Our Case Number: ABP-317767-23

Re: Proposed construction of 39 residential units, widening of Pausdeen Bridge and all associated site works.
Newtown/Ardclough Road, Newtown, Celbridge, Co. Kildare.

Planning Observation Submissions to An Bord Pleanála

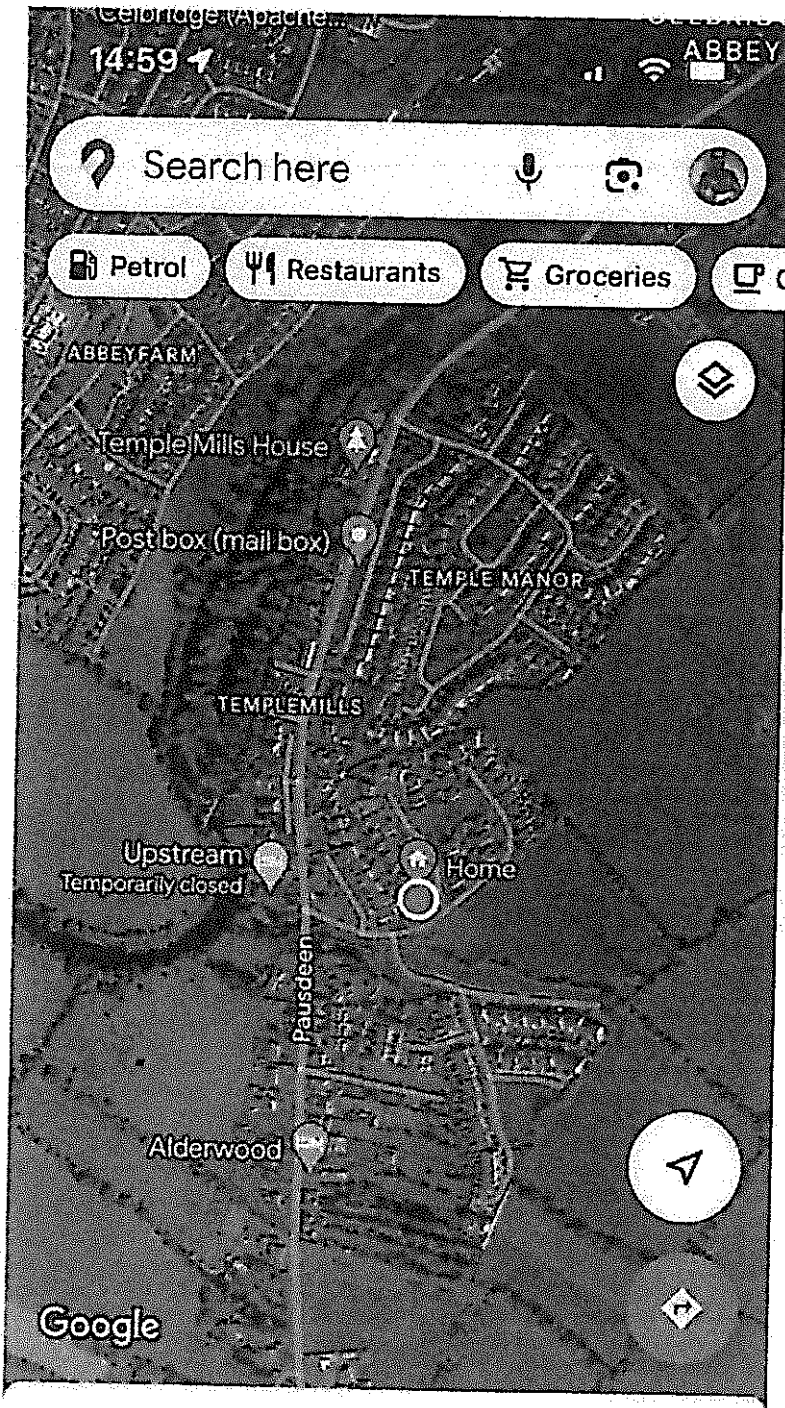
The diagram below shows that the site boundary (40m from river) would be the closest development to the flood plain on the west side of the Ardclough Road. No other development is as close to the Liffey flood zone on the southern side of the river.

Section: 3.8 problem

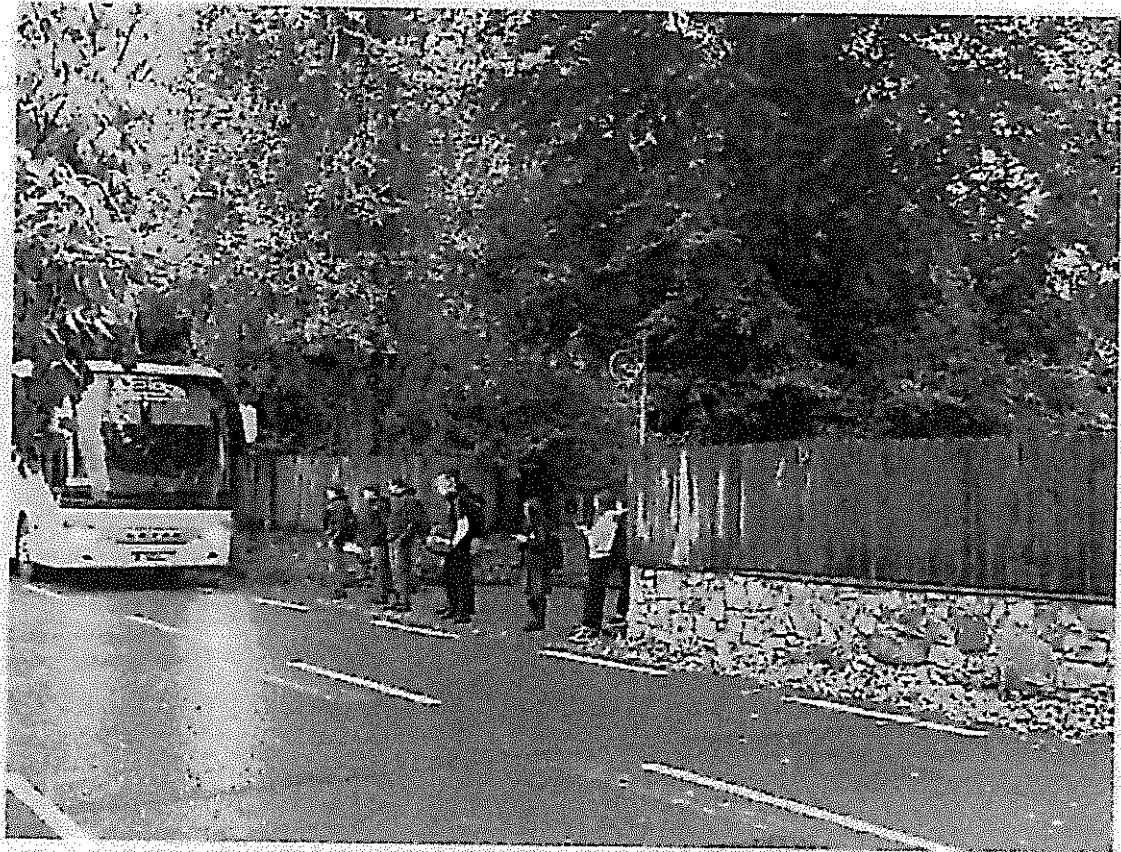
Location: Drawing 210303-2-007 – Rev – VHA, Pedestrian Bridge

Information in the Bruton Consulting Engineers Road Safety report is not true or correct. The entrance at Chelmsford is an extremely busy junction during peak times (Work / School Times etc.). The entrance is the only access to Chelmsford and Chelmsford Manor Housing Estates which has a total of 95 Residential houses. Each house has an average of two motor vehicles which in turn means 190 motor vehicles can pass through the entrance at any one time. There is no dedicated bus stop for the children of Chelmsford going to school. This applies to the new Council Estate in Newtown recently acquired and the proposed site. There are no bus stop facilities at Simmonstown and Templemanor for children going to school on the bus. Note that cycling is not an option as there are no cycling routes.

Section: 3.9 problem

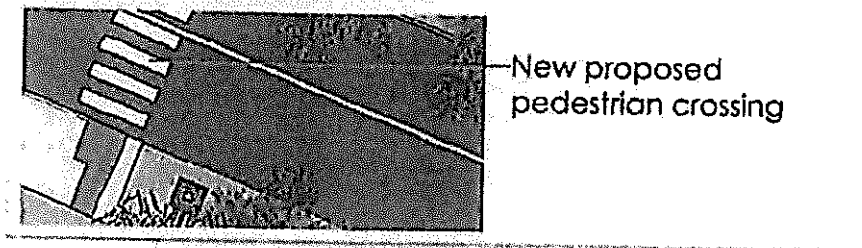
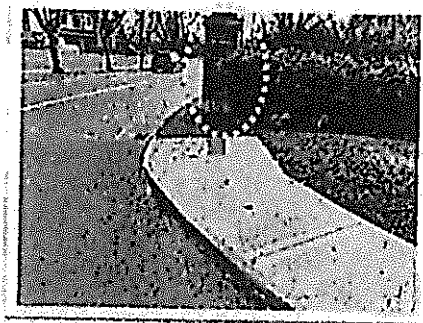
Location: Drawing 210303-2-007 – Rev – VHA, Pedestrian Bridge

The information in the Bruton Consulting Engineering Report or KCC Planning Application Report does not consider the ownership of the Common Green Areas at Entrance along with the two Pillars at the entrance to Chelmsford. The lands are not owned by the County Council, and they will need permission from the owner to carry out any works on this proposed site.

Resolution: The Chelmsford Residents Association should be given documented evidence that permission from the owner that any works on the planning application for bridge widening and new proposed zebra crossing has been given.
